CONSULTATION RETURN: DC/19/03486

PROPOSAL: Outline Planning Application (some matters reserved - access to be considered) -

LOCATION: Land south west of Beyton Road Thurston Suffolk

A143/C691 Bunbury Arms junction

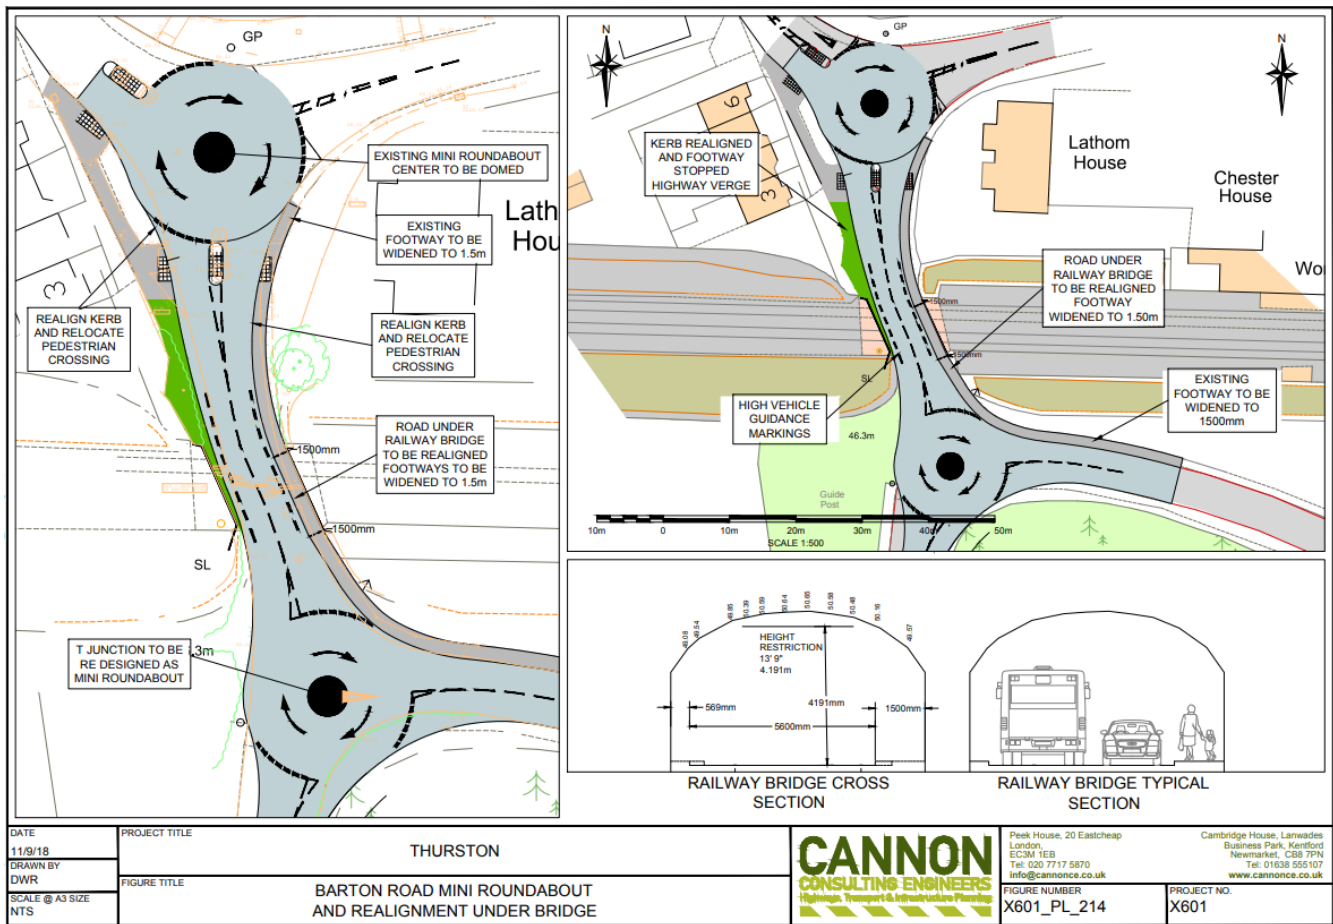
Existing situation	Proposed mitigation
<p>The mitigation from the 2017 developments included signalling the junction. The junction will be at capacity on two arms in the AM peak hour for the granted applications. This was accepted as the developments had mitigated their impact, but it was not possible to fully mitigate the background growth due to space constraints.</p>	<p>The proposed mitigation with contributions from the previous 5 applications, the 2019 AECOM indicates that the one arm of the junction will be over capacity during the AM peak hour and at capacity on two arms. On further assessment of the model data, we believe there is scope to improve the proposed preliminary design of the signals using better software and monitoring systems to improve capacity. However, no further mitigation, in terms of highway layout, is considered possible within the highway boundary.</p>

The impact on this junction is minimal from this development’s traffic as the dominate movement is south or west; towards the A14. Modelling in the applicant’s Transport Assessment shows the junction percentage impact from this site would be less than 1%. It has been assumed that the direction of trips can be based on census data showing their destination. Also, due to its location south of the railway line, it is likely that drivers are more likely to travel via the A14 to reach destinations West and North of Bury St Edmunds and trips via the Bunbury Arms Junction will be less than anticipated.

We also believe that the provision of a signal junction at the A143 junction will potentially result in a redistribution of traffic due to the additional delay for left turn out movements. The signals could also increase the right turn movements from Thurston, as it becomes more attractive manoeuvre no longer being directly opposed.

Barton Road Mini Roundabout and Rail Bridge/Beyton Road junction

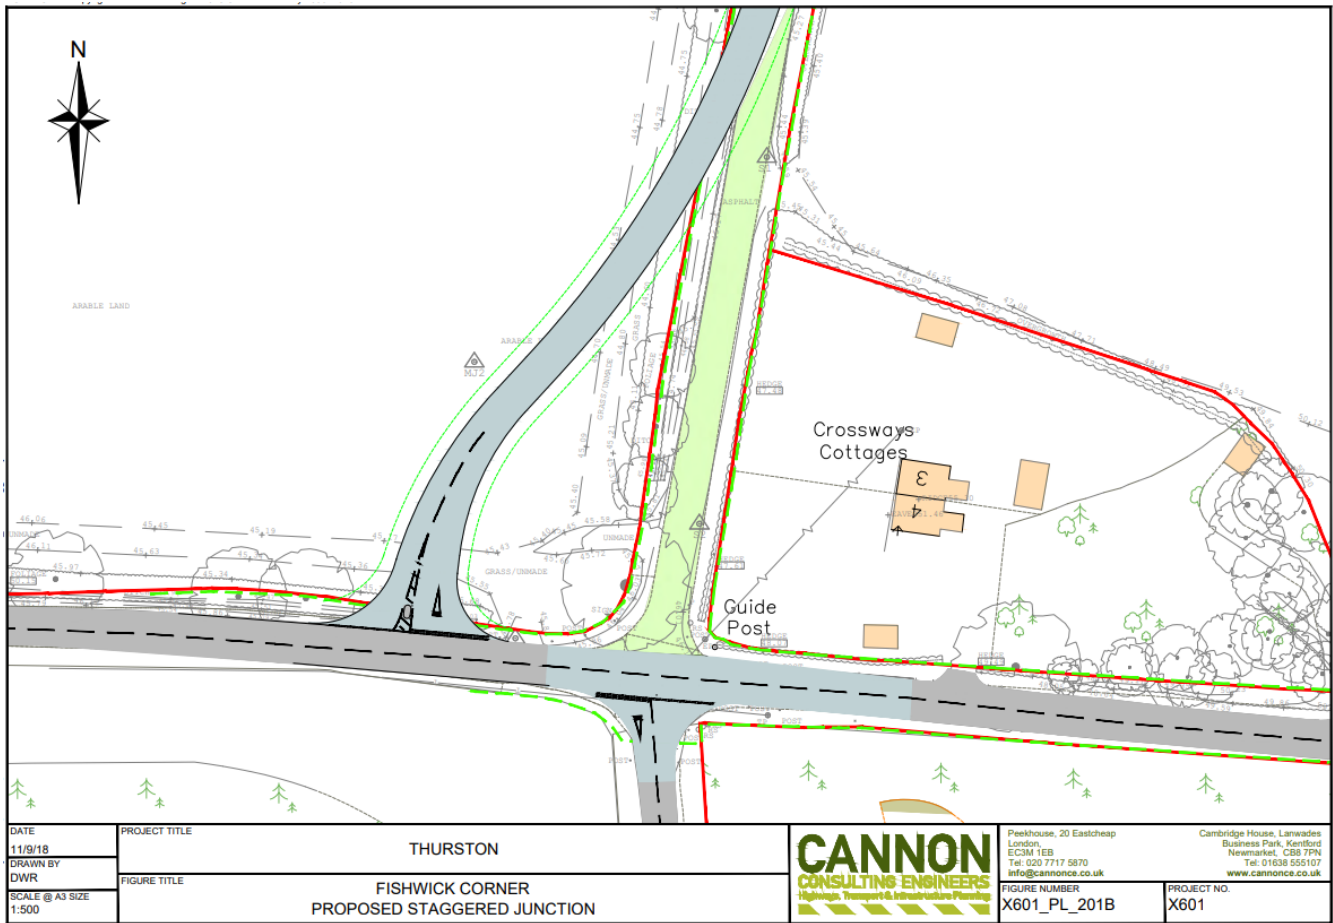
Existing situation	Proposed mitigation
<p>Barton Road under the railway bridge has sufficient carriageway width to allow 2 cars to pass. However, with the arch of the bridge, high-sided vehicles have to use the centre of the carriageway to use the maximum height of the bridge, therefore no other vehicles can pass large vehicles except cyclists. Due to the height restriction of the bridge, use by high sided vehicles is restricted (single deck buses can use this route). The footways under the bridge are narrow; where the west footway terminates adjacent to the south-west bridge abutment 490mm wide and the other has a pinch point of 750mm.</p> <p>The carriageway is not parallel with the bridge abutments which restricts the forward visibility from Beyton Road junction under the bridge to 24.5m.</p>	<p>By introducing improvements to the existing mini-roundabout and a new mini-roundabout on the Barton Road/ Beyton Road junction, this improves the RFC for Base + Committed Development + the Development from 1.00 to 0.85 and reducing delays by approx. 60 seconds therefore, improving capacity. By realigning the carriageway parallel with the bridge abutments, will improve the inter-visibility between the junctions on each side of the bridge. Removing the footway on the west side enables the footway on the east to be widened to 1.5m enabling safer passage for pedestrians making an acceptable walking route for existing and new residents. Access for cyclist remains poor as the footway is too narrow restricting them to the road and hence potential conflict with vehicles.</p>

Barton Road Rail Bridge: Straightening of the road will improve sight lines for drivers and provide a 1.5m wide footway on the east side. While the width of footway is less than desirable, particularly next to a busy road we have considered that on balance we would not consider it so unsafe as to recommend refusal. However, this is a judgement made on the likely number of pedestrians from this development and any additional pedestrian use, particularly if it involves vulnerable users, would need to be reassessed. The problem of higher vehicles having to use the middle of the road to avoid the low arch remains a hazard

as does the limited capacity albeit with a degree of improvement to the flow by the proposed mini roundabout south of the bridge. Balancing the improvements in footway, better sight lines and alignment against the remaining limited capacity we consider that on balance This is regarded as a benefit in highway terms sufficient for this development.

C693 Thurston Road/C692 Thurston Road junction (Fishwicks Corner)

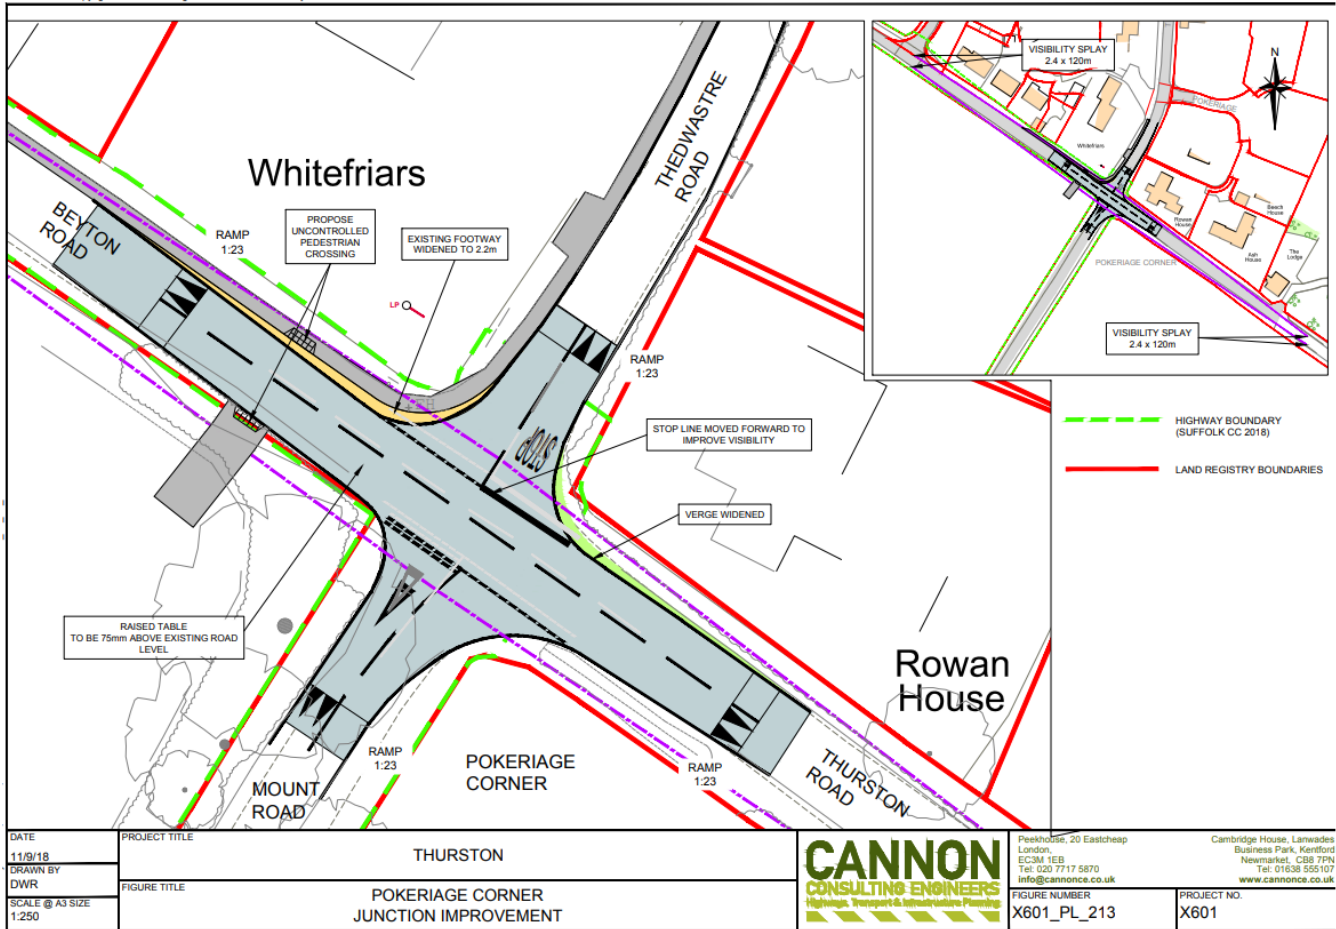
Existing situation	Proposed mitigation
<p>At Fishwicks Corner the primary cause for congestion is due to limited visibility at the junction. Being a crossroads with four-way movements also reduces capacity and adds to delays. The junction is an accident cluster site with 13 recorded injury accidents; 11 of which were drivers failing to look properly on the minor arms of the crossroads due to poor forward visibility. As part of the mitigation for the 2017 developments, a 40mph speed limit is being introduced with a change in the junction priority and altering the give-way scenario to Stop lines on the side roads. The predicted RFC with the 2017 developments following the revised layout of the junction was calculated as 0.93 in the PM peak.</p>	<p>The land to the north west of the junction is within the developers control so the highway boundary is no longer a constraint for further highway improvements to improve safety and capacity of the junction. The dominant turning movement in the AM peak is from Thurston Road (north arm) turning right to Bury St. Edmunds and in the PM peak, from Bury St Edmunds turning left into Thurston Road (north arm). By introducing a staggered junction, this improves the RFC for Base + Committed Development + the Development from 1.10 t(unmodified) o 0.58 and reducing delays by approx. 3 minutes therefore, improving capacity. Also, staggered junctions will provide the required visibility for the speed of road (40mph) and this type of layout has been shown to reduce accidents by some 60% compared to a crossroads. Recently, a preservation order has been applied to trees next to the existing junction but these are unaffected by the proposed new junction</p>

The question of a roundabout in this location has been raised by councillors. While an acceptable solution it is not concerned proportionate to the scale of the development as the proposal for a staggered junction delivers sufficient mitigation. Also, a roundabout would require a large area of land, are less safe for cyclists than to any other kind of road layout and there would be a need to remove more trees. possibly those recently protected. SCC have also requested additional area of land to be secured to allow for a future cycle/footway scheme if that is considered necessary.
